Maharashtra Metro Rail Corporation Limited
(A joint venture of Govt. of India & Govt. of Maharashtra)
Nagpur Metro Rail Project - Phase 2

Corrigendum-II

Tender No: N2-010/C-04/2023 dated 07-Sep-2023

Name of Work: Design and Construction of Elevated Metro Viaduct of length 5.333 km between Ch. (-)289.668 m to Ch. (-)5622.577 m in Reach 4A of NMRP Phase-2

| Reference | Existing Provision | Revised Provision |
|--|---|---|
| GAD DWG NO. MM/PIg/NIT/NGP PH-II/4A/R1/2023 | GAD - DWG NO. MM/PIg/NIT/NGP/PH-II/4A/R1/2023 (Sheet 1 to 8) dated 12-July-23 | Revised Drawings are attached with this corrigendum: GAD - DWG NO. MM/PIg/NIT/NGP/PH-II/4A/R2/2023 (Sheet 1 to 8) dated 26-Oct-23 |

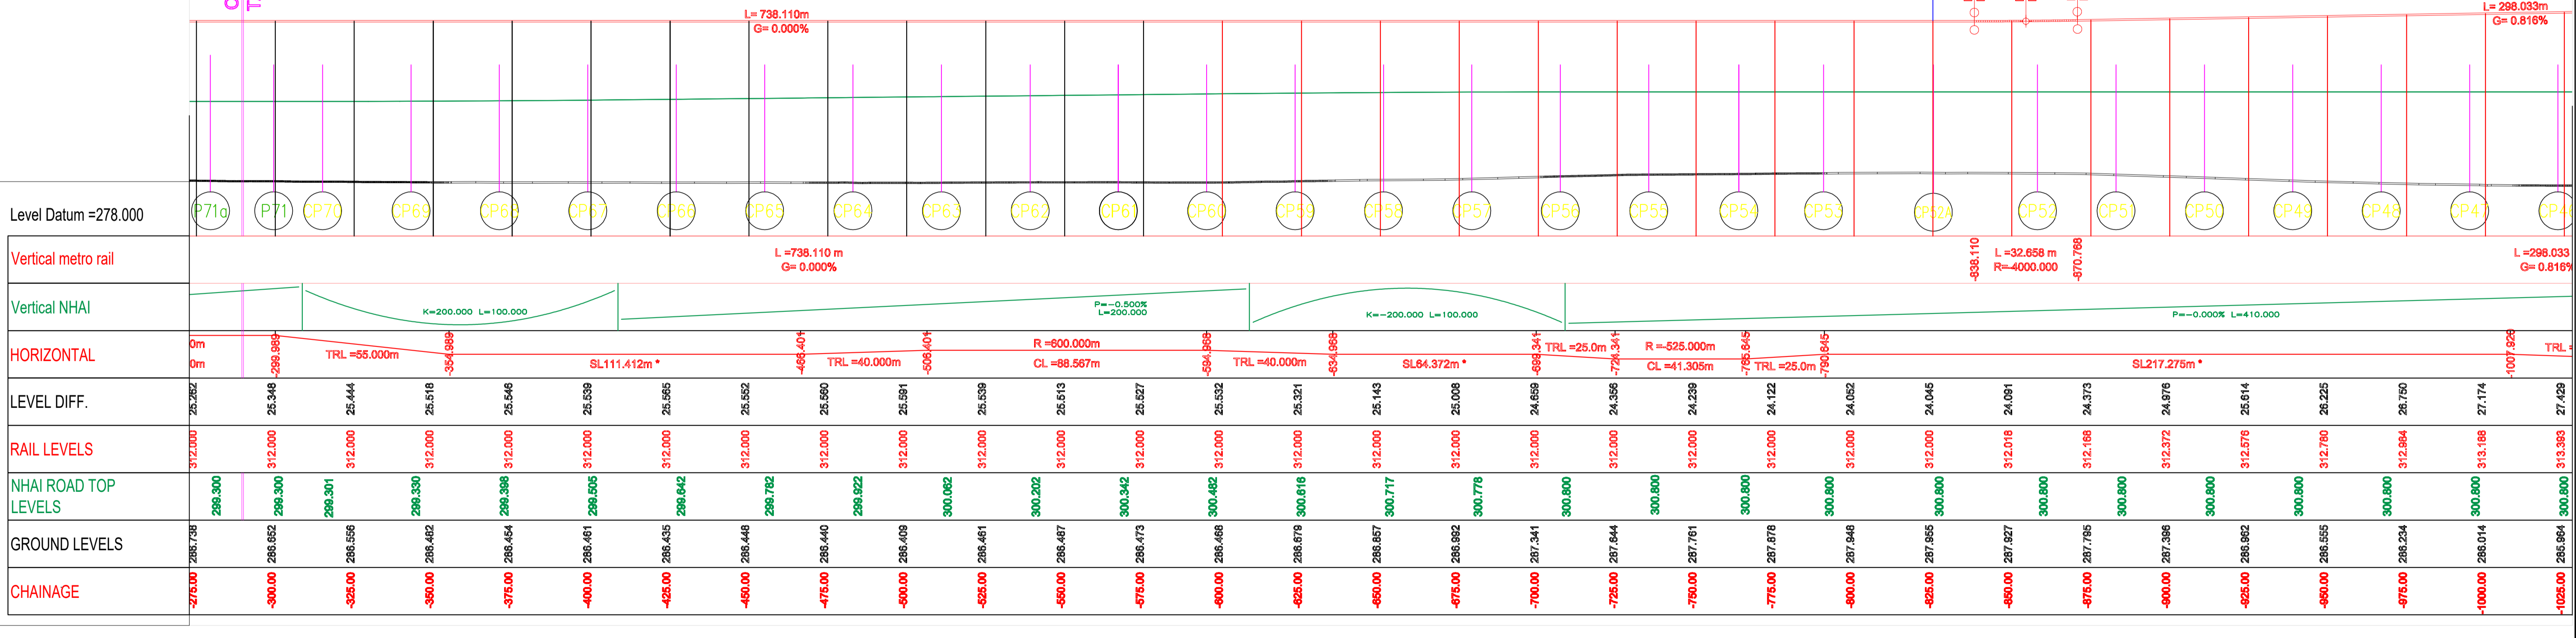
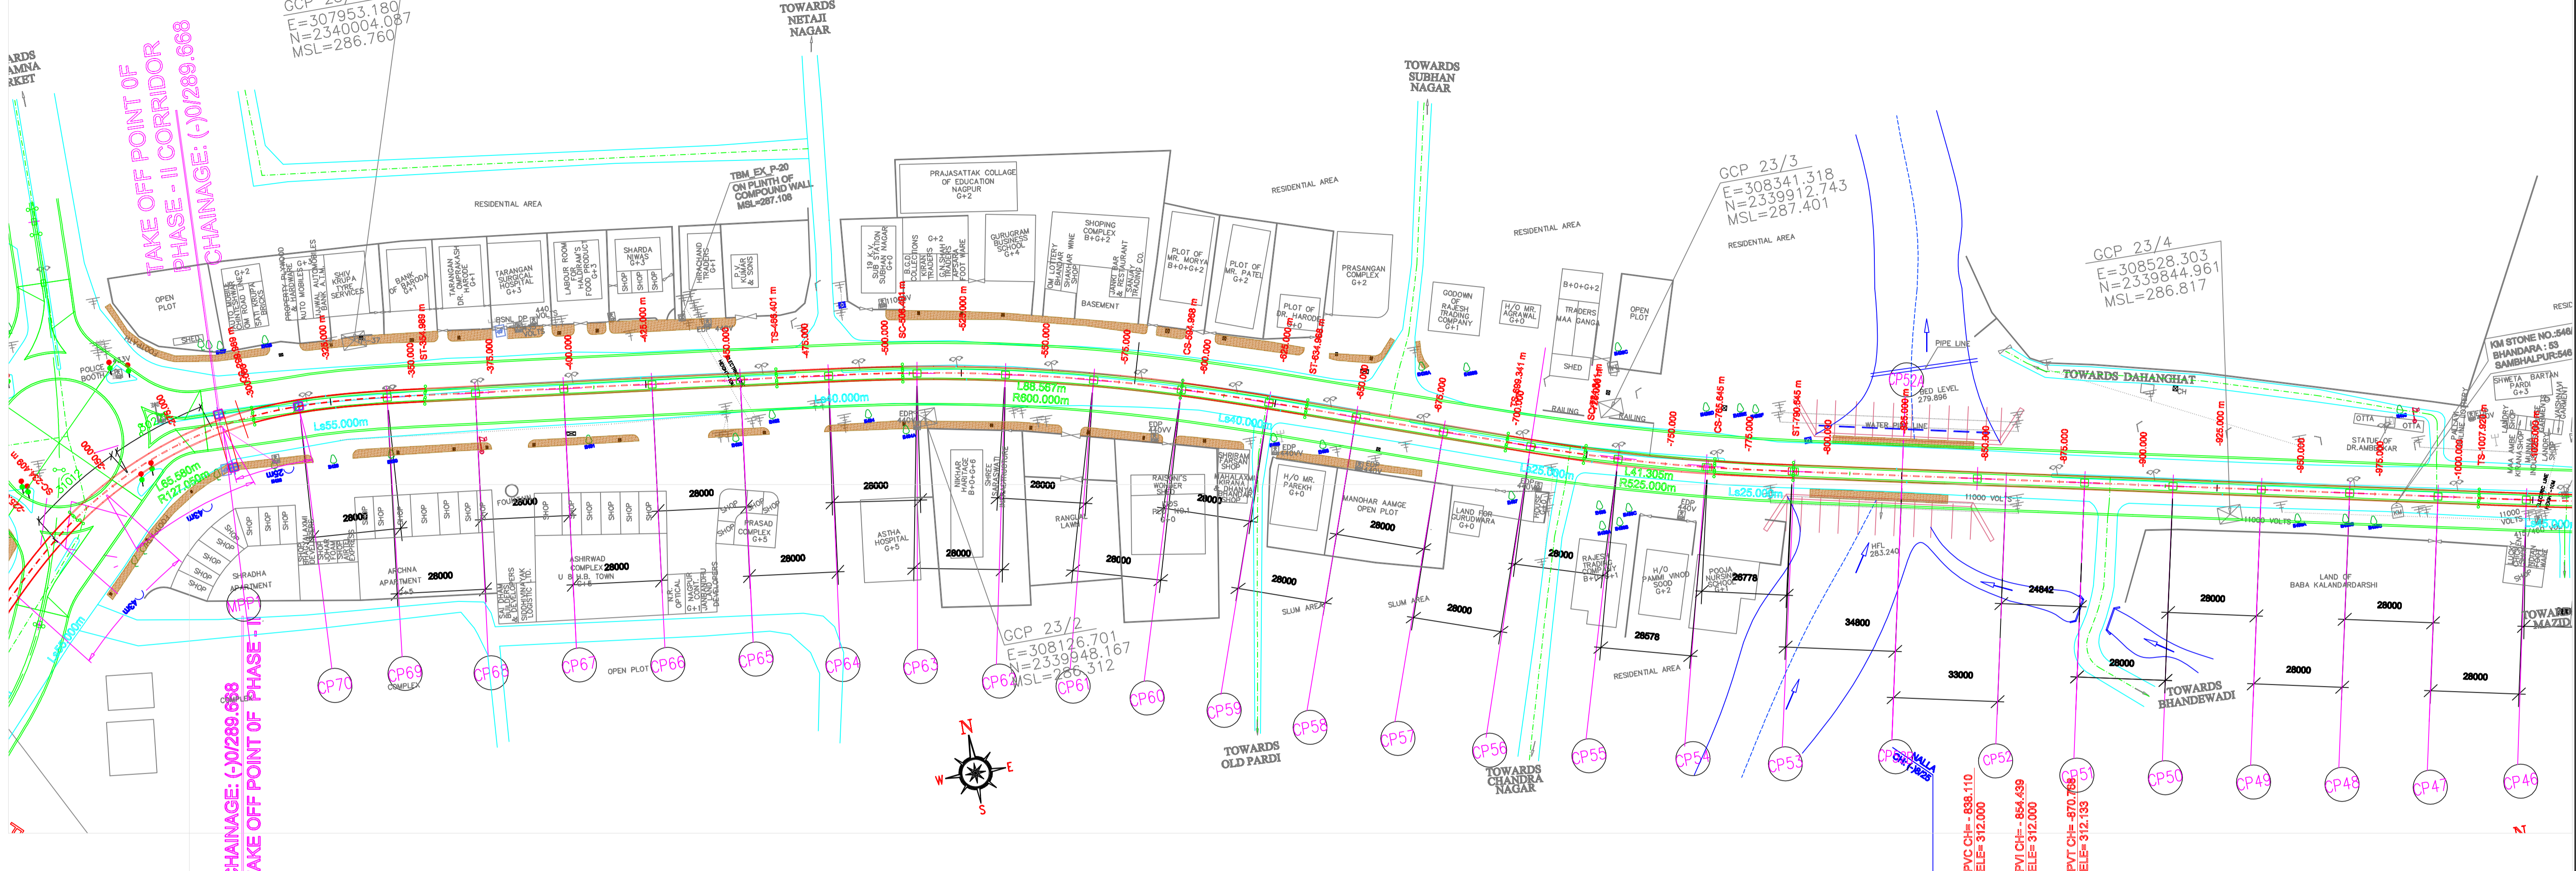
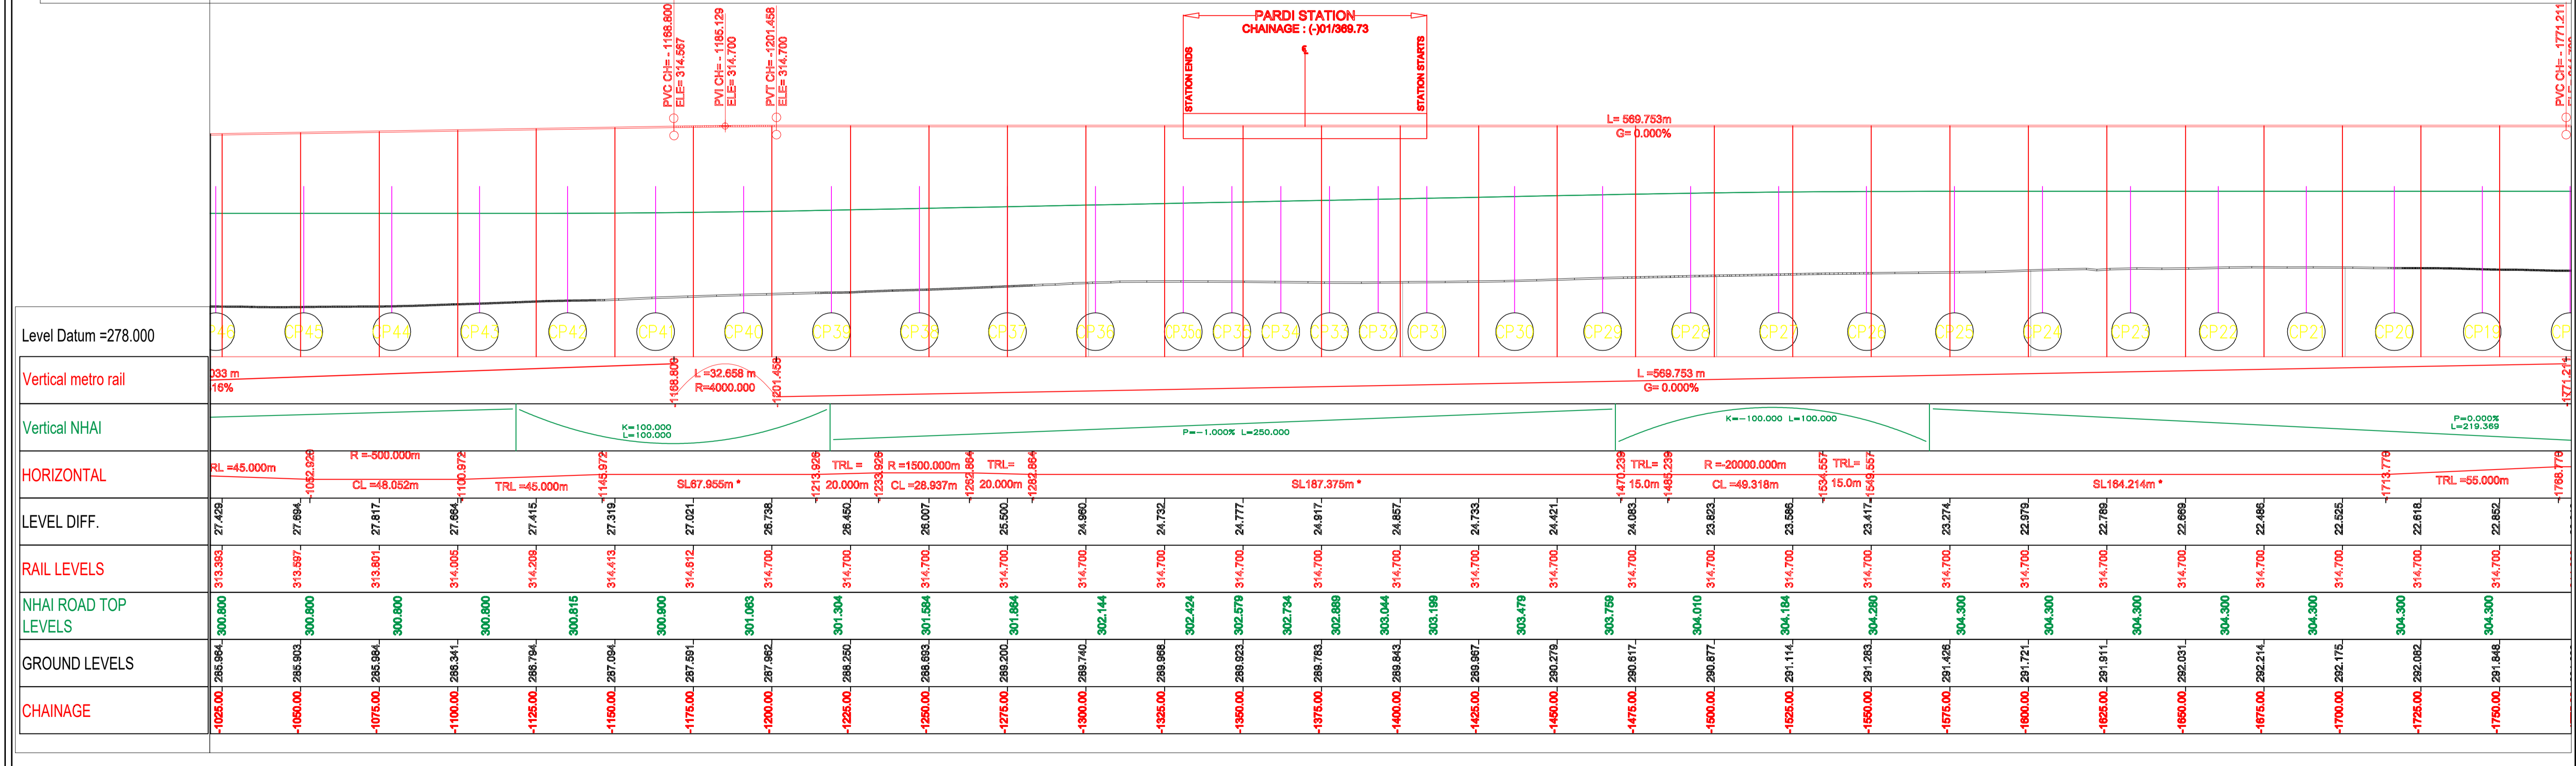
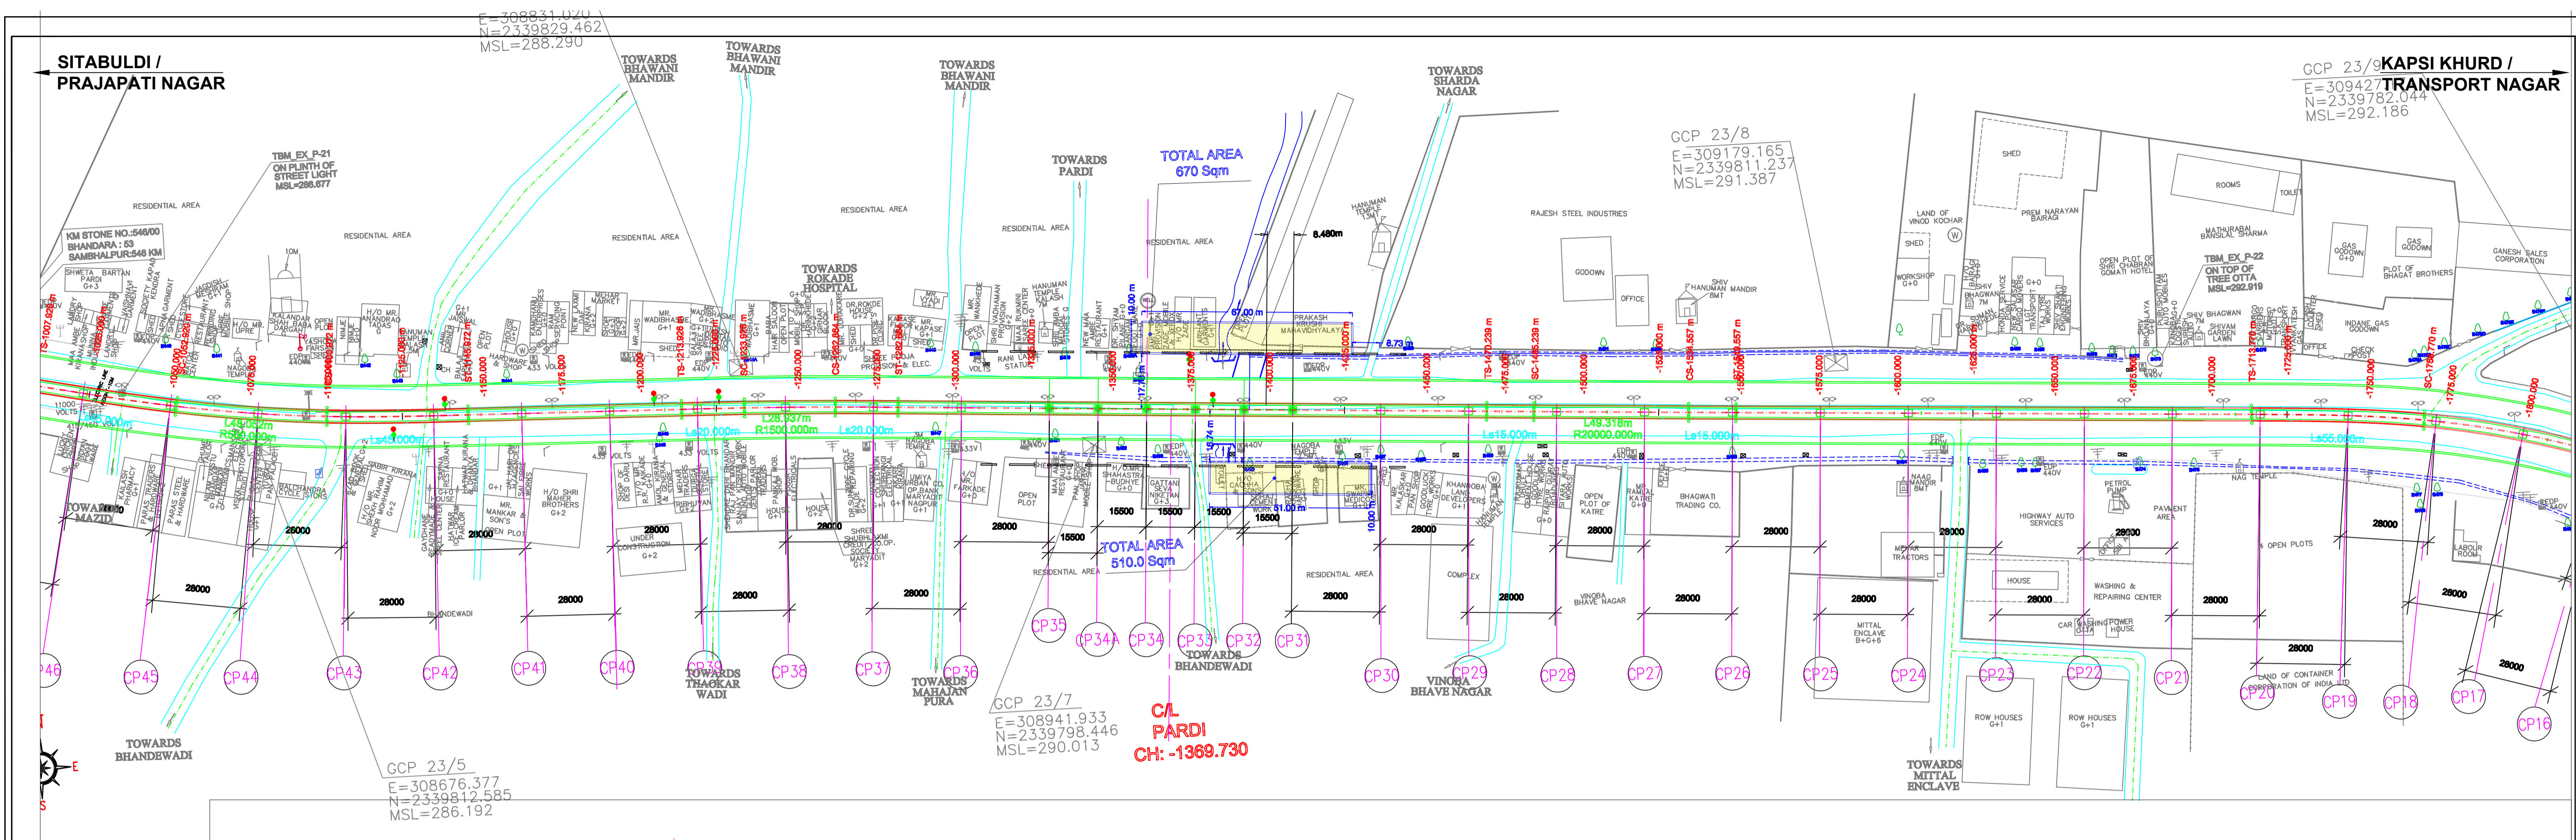
| Reference | Existing Provision | Revised Provision |
|--|---|---|
| Note no. 2 in GAD | Vertical profile as indicated in this tender drawing is based on GL/Road Level as surveyed during preparation of DPR in 2018. However, Contractor will have to ascertain its final value and maintain the requisite vertical clearance of 5.5m from existing/finished Road top level (as on date) to soffit level of Metro Superstructure. | Vertical profile as indicated in the tender drawing is based on GL/Road Level as surveyed during preparation of DPR in 2018. Maha-Metro Doesn't own any responsibility for the accuracy of the same, Contractor will have to ascertain its final value and maintain the requisite minimum vertical clearance of 5.5m from as built flyover Road top level (as on date of construction) in consonance with provision of IRC: 86-2018 from CH: (-)289.668 to (-)2250.000. Also, From CH: (-)2250 to CH: (-) 5560.827 shall maintain minimum vertical clearance of 5.8m from the existing road level. |
